Public Hearing Staff Analysis
CZ-2-2024
627 East Main Street, PID 00670

Morris Long is requesting a conditional district rezoning of 0.733 acres for the purpose of creating four duplex residential units

PROPOSED ELEVATIONS

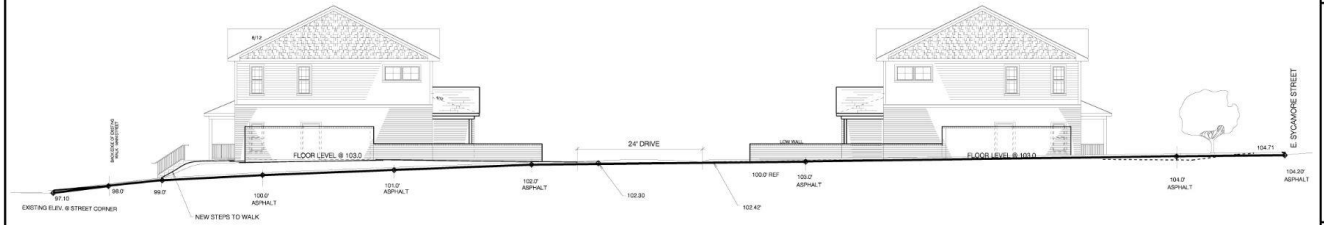
- Building plans must be submitted to and approved by Lincoln County Inspections prior to development.
- Windows and doors must be similar to CB Design Code Standards for downtown buildings.
- Building design is to be generally consistent with the quality, character and fenestration portrayed in the renderings. Minor variations from the renderings that do not detract from the quality, character and fenestration may be permitted.
- Landscaping along the length of Sycamore where it is across from Single Family Dwellings. Use Street Landscaping Standards 4 small trees, 12 shrub per 100 linear feet

Planning board voted 7-0 in favor of the project with the condition that the front facade of the units on Main Street be brick veneer as opposed to a combination of brick and hardie board.
